ADDENDUM ONE
HIGHLAND PARK (ANDERSON AVENUE) GI DEMONSTRATION PROJECT
CONTRACT NO. S-11-001-201
CITY OF CHATTANOOGA, TENNESSEE

The following changes shall be made to the Contract Documents, Specifications, and Drawings:

III. Updates to Drawings

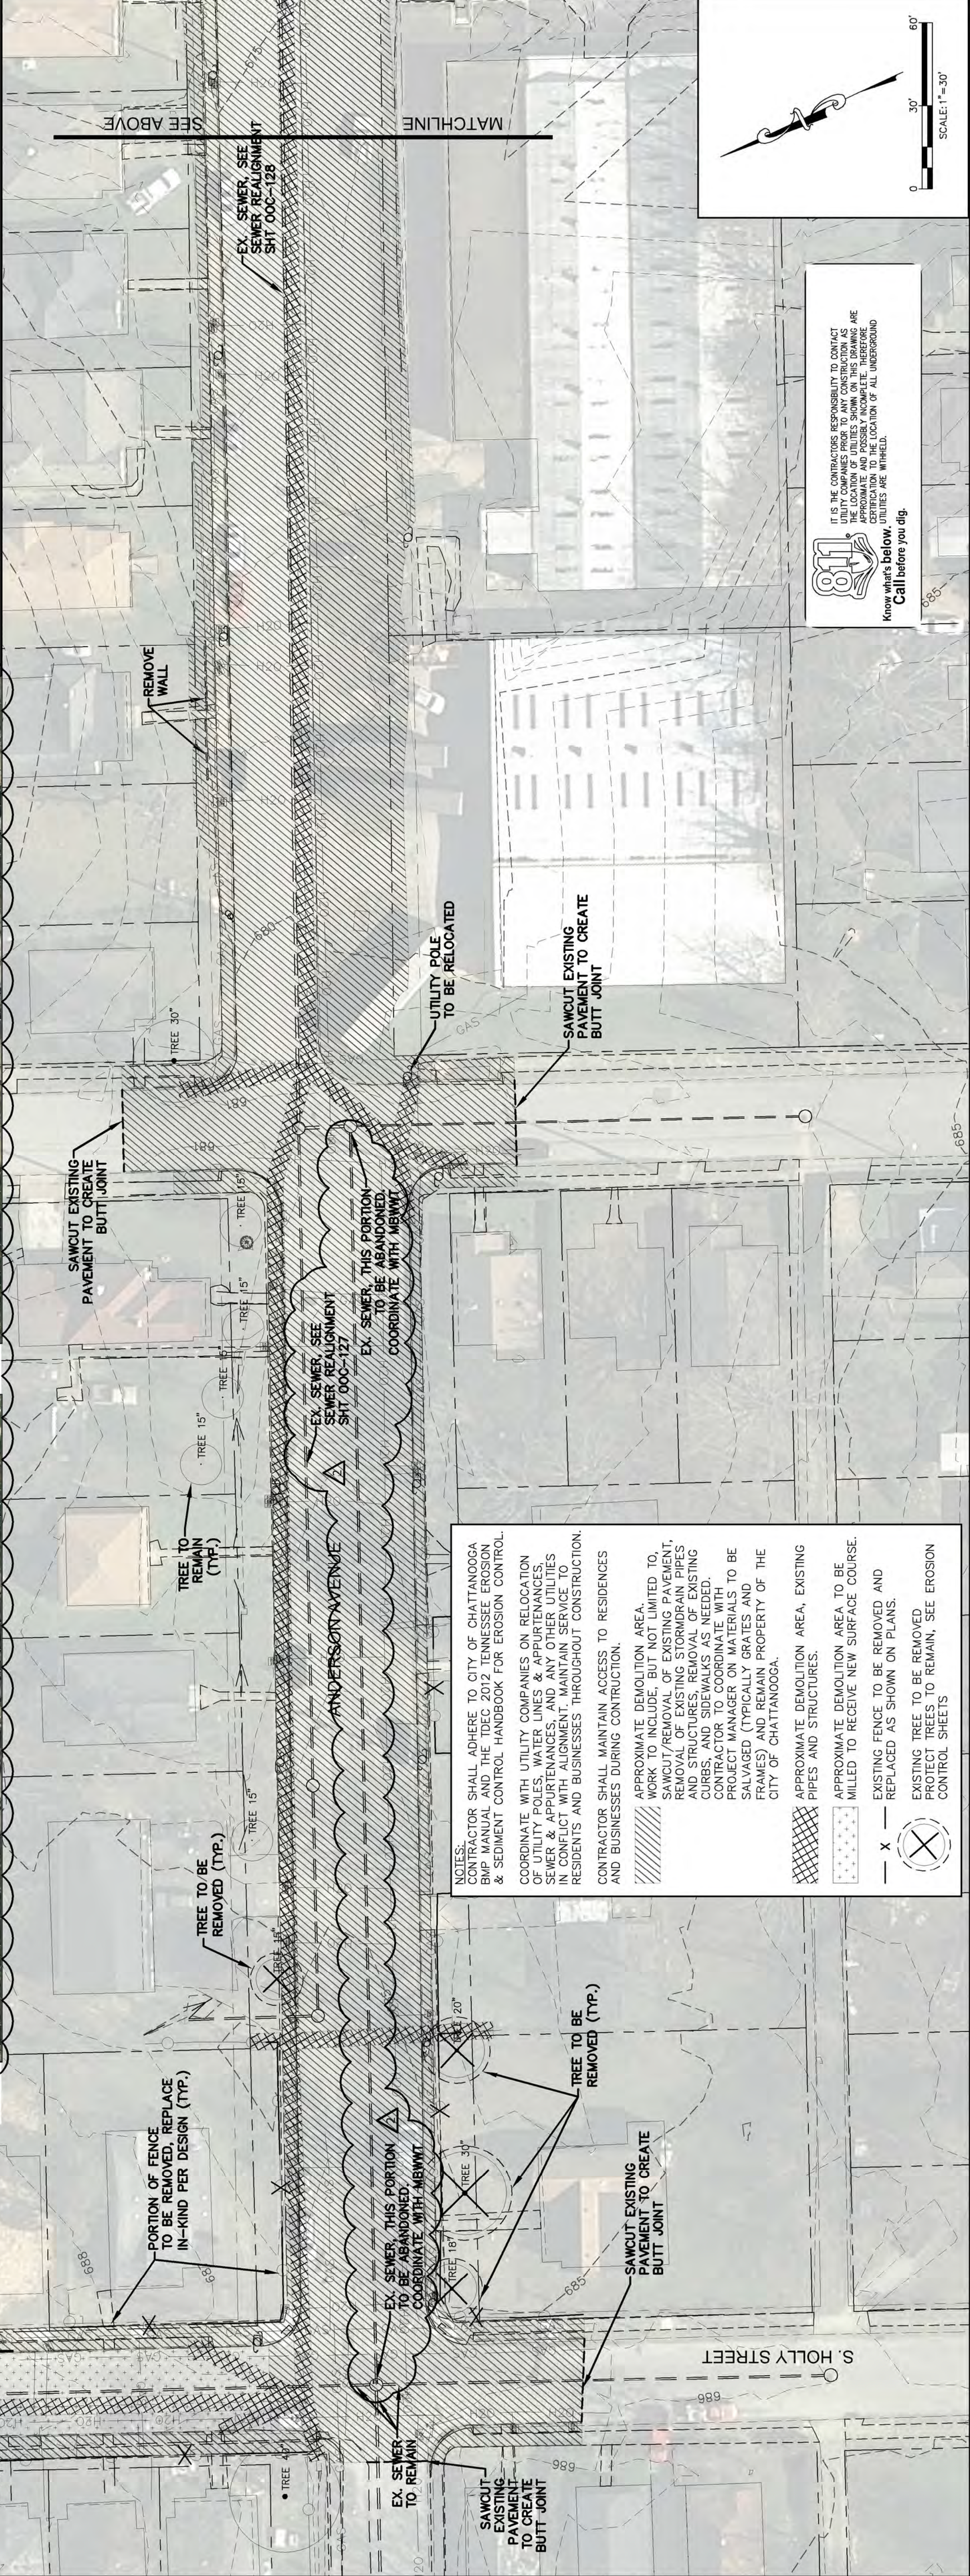
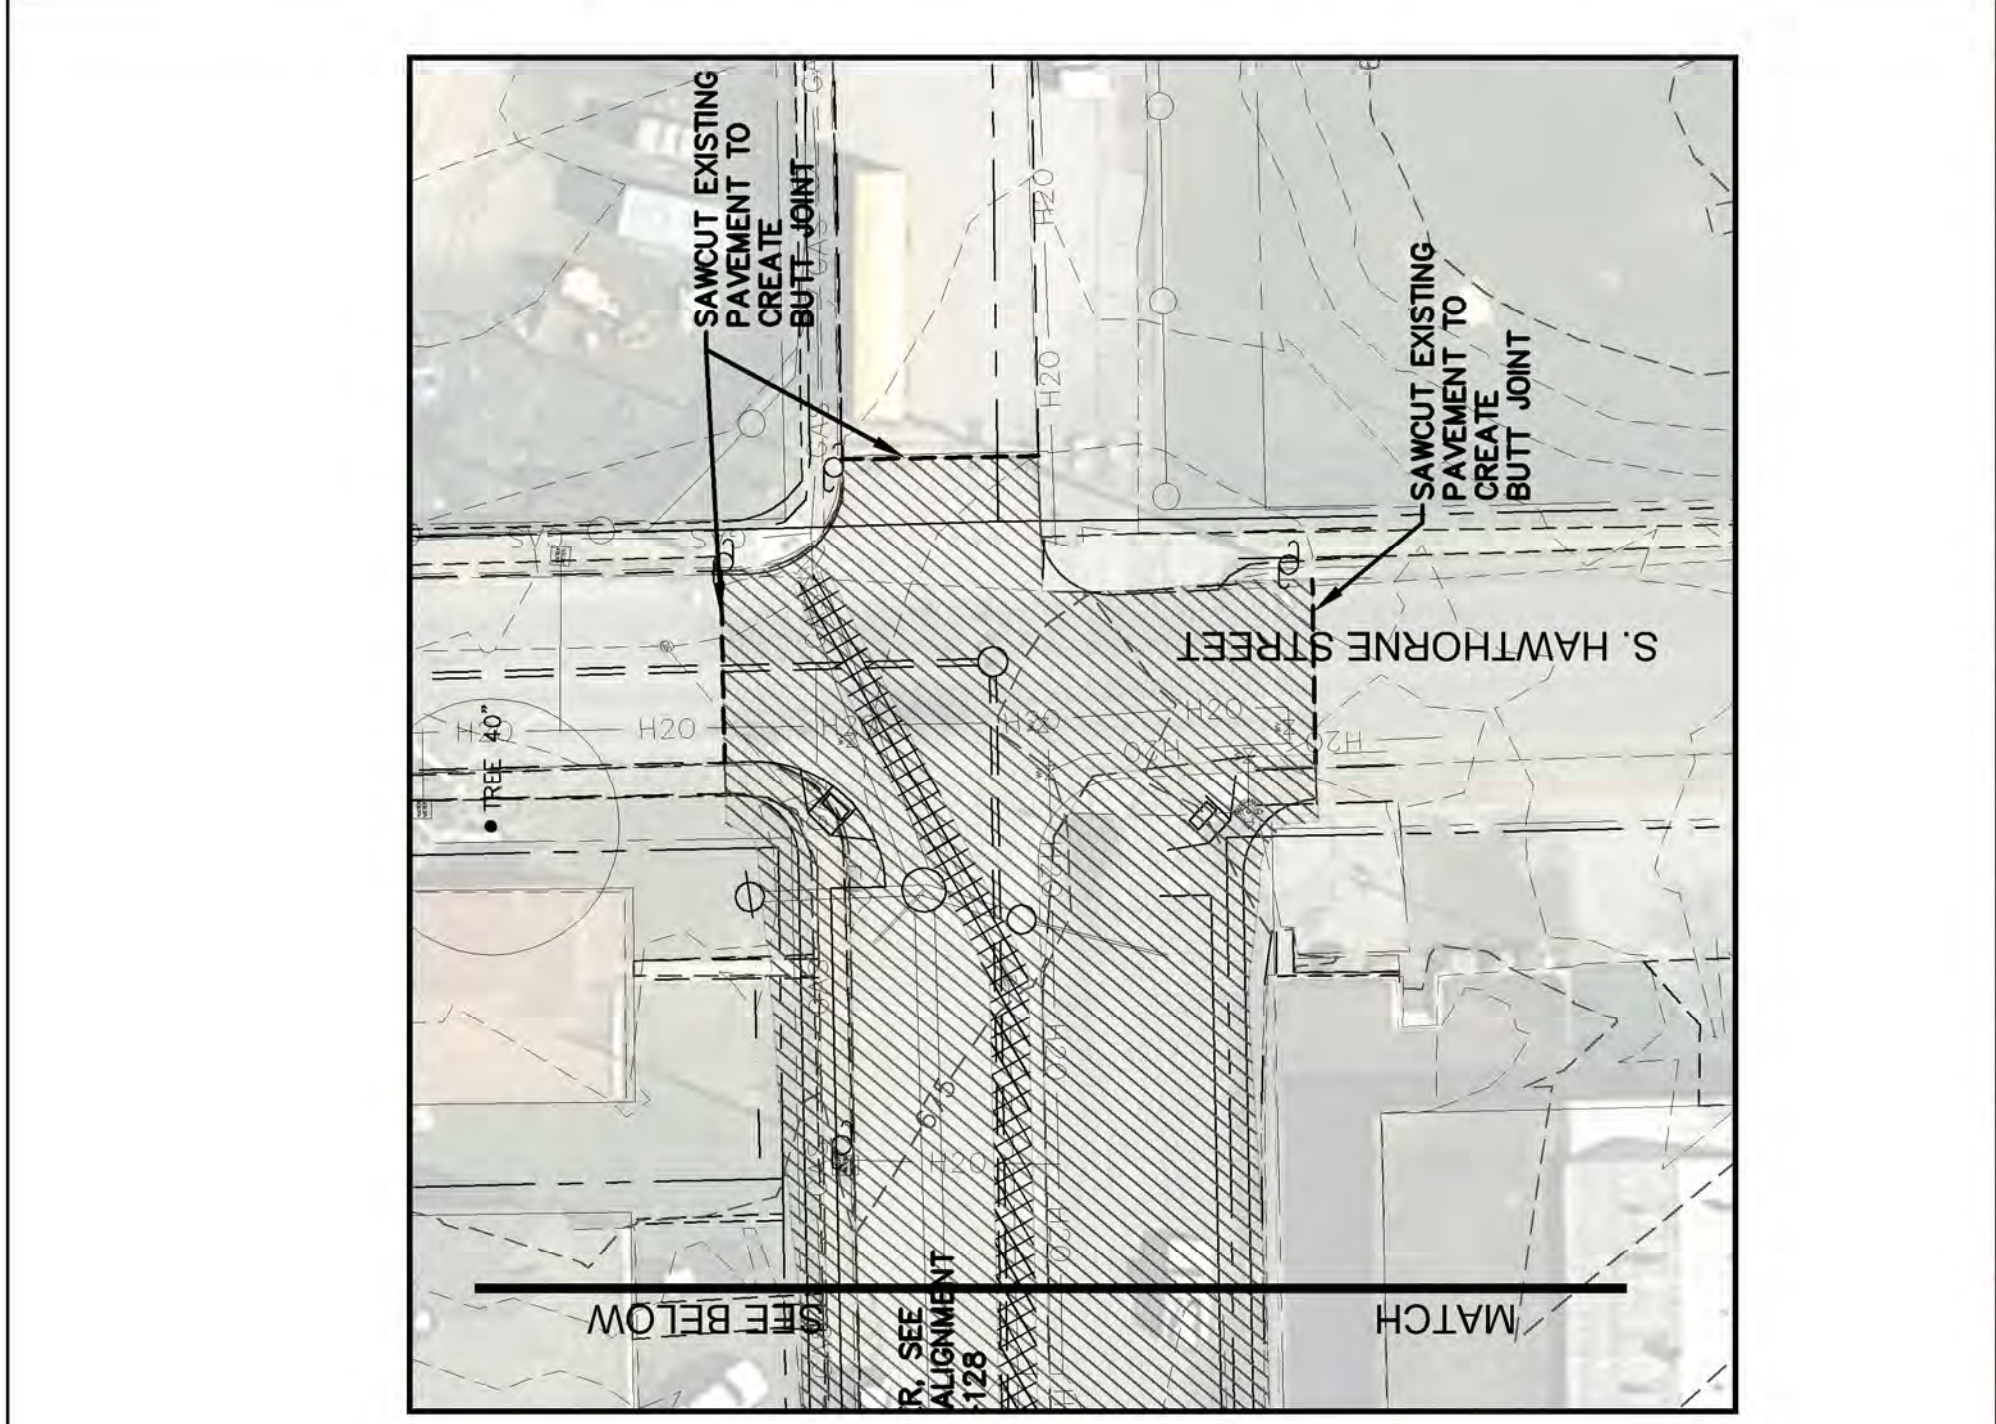
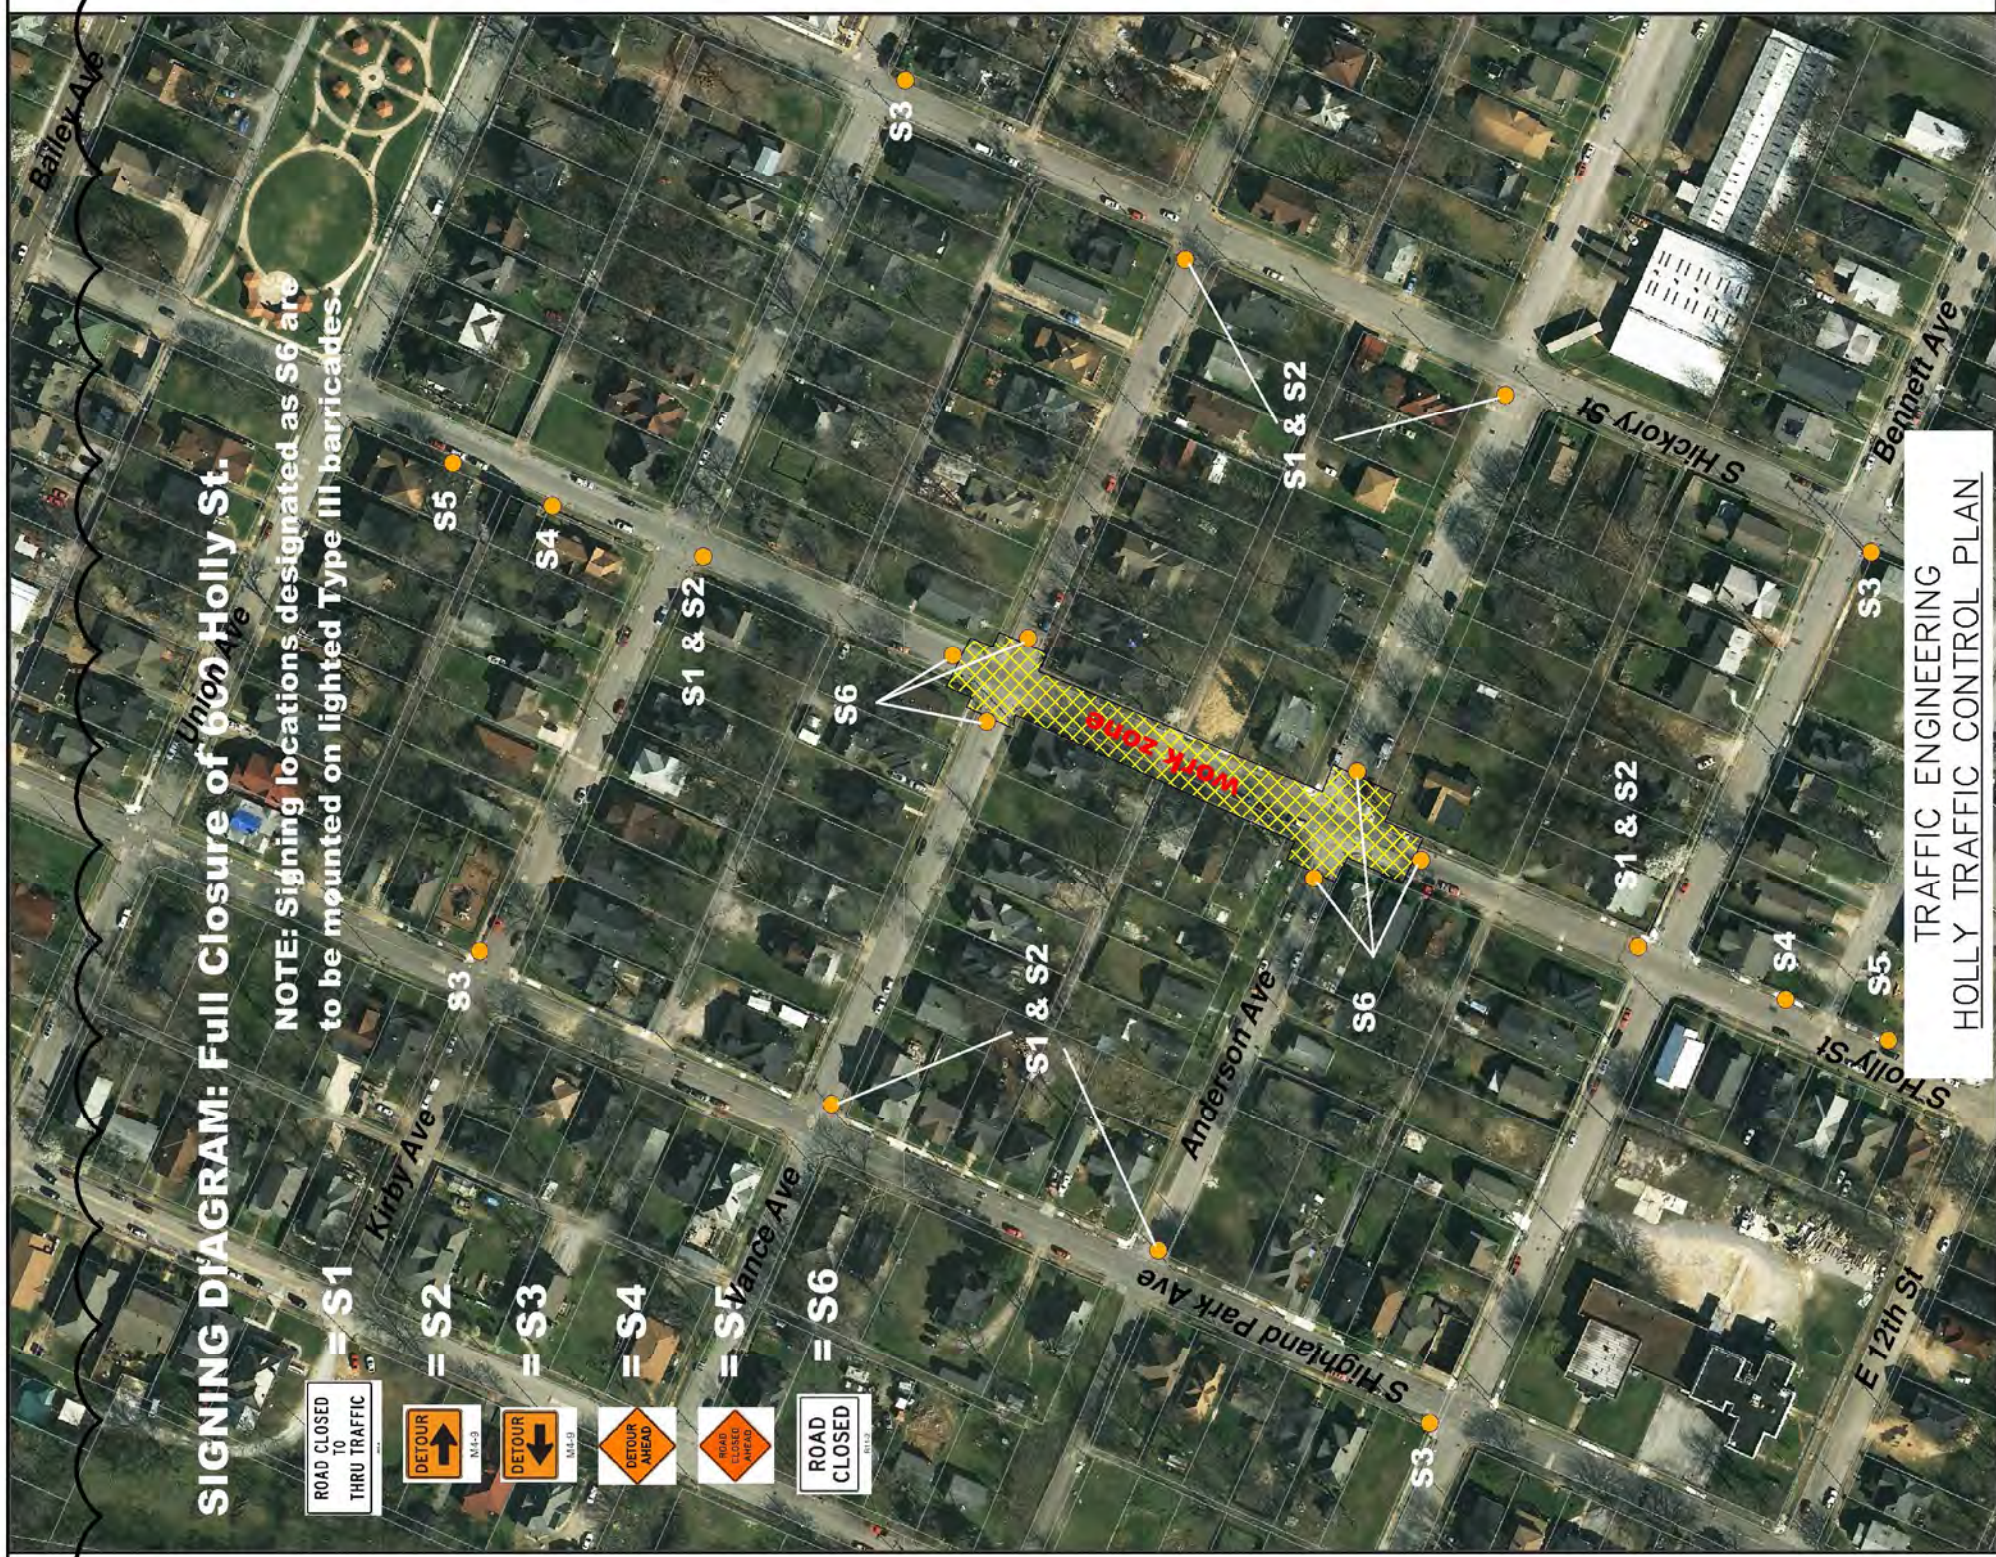
Shts 00L-101 and 102 Alt A revised, bid tab revised to reflect changes
